FINAL DRAINAGE REPORT

SPACE VILLAGE FILING NO. 4 EL PASO COUNTY, COLORADO

PCD FILE NO. MS-22-007

SEPTEMBER, 2022

FIGURE 1 - BORING LOCATION DIAGRAM
PROPOSED STORAGE YARDS
0 SPACE VILLAGE AVENUE
EL PASO COUNTY, COLORADO
CGG PROJECT NO. 22.22.155

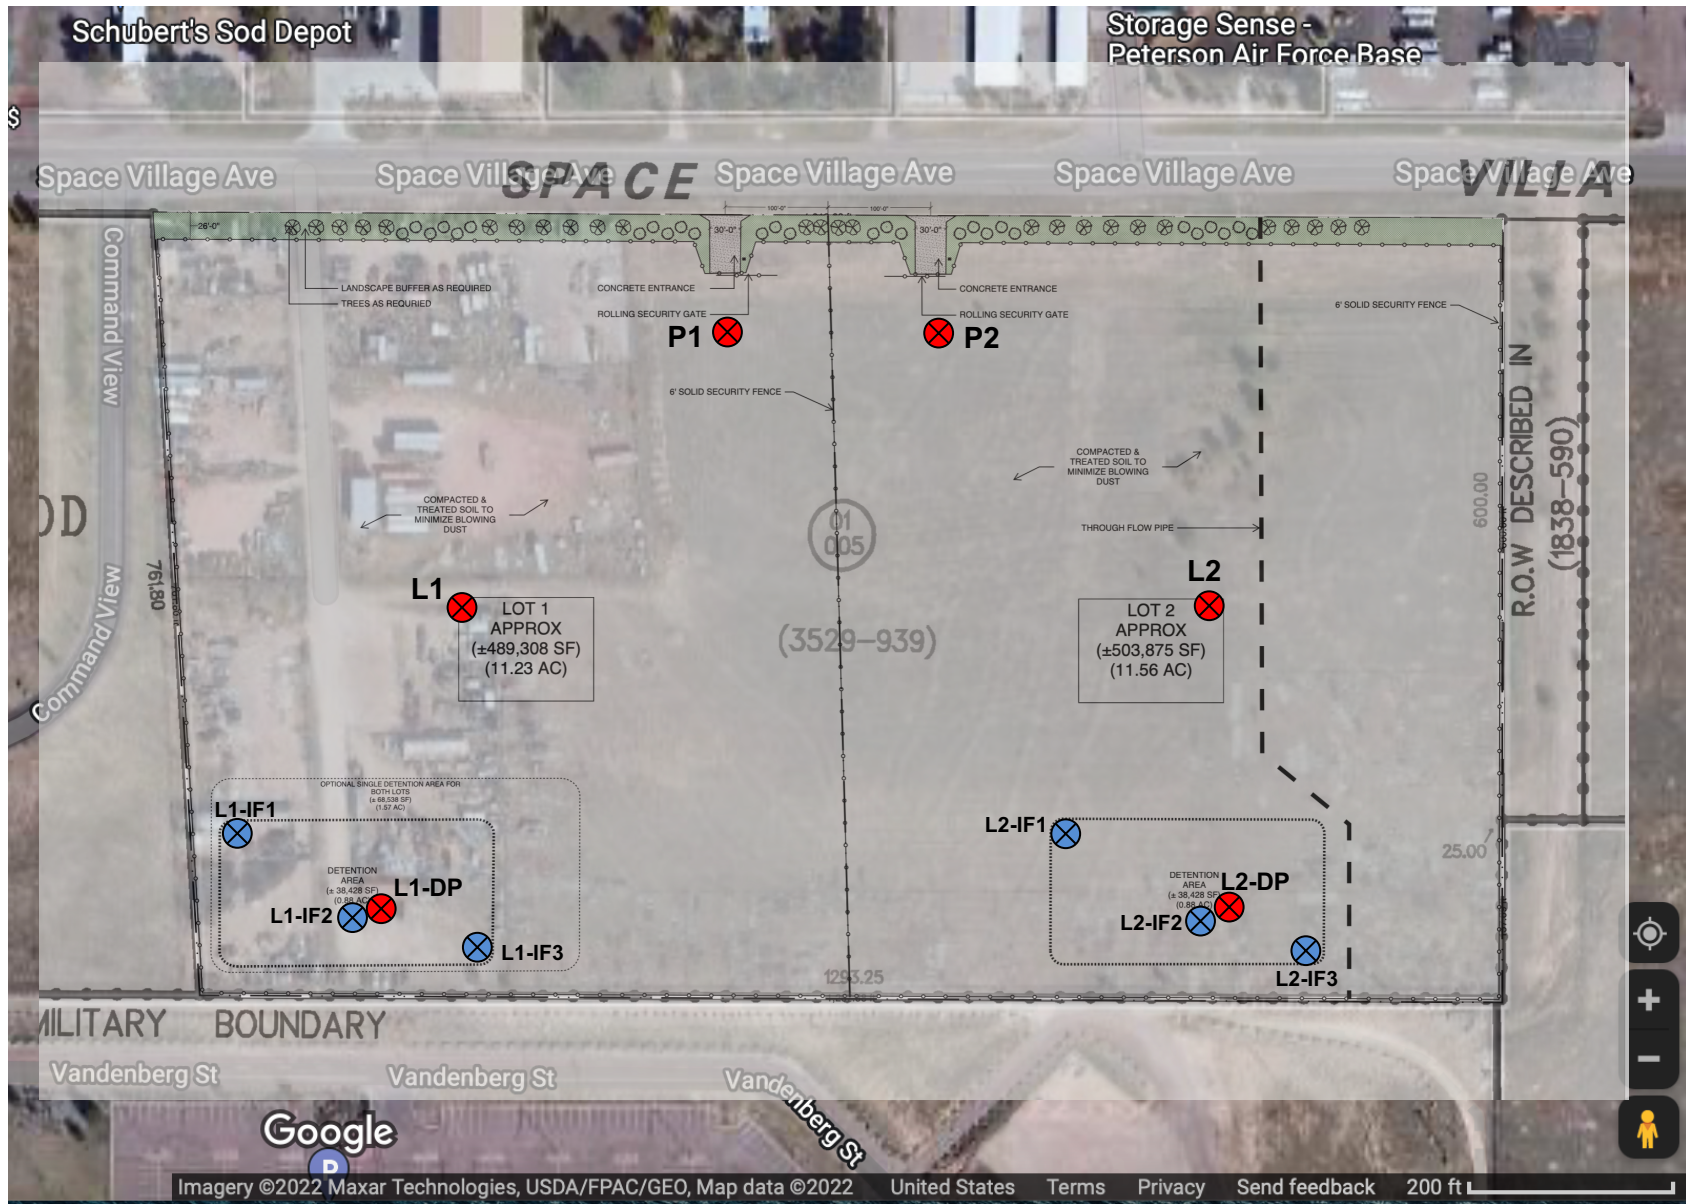
Per boring location map it appears that L1-IF2 and L2-IF2 are also in proximity within the pond locations. Please take these test holes into account and revise accordingly.
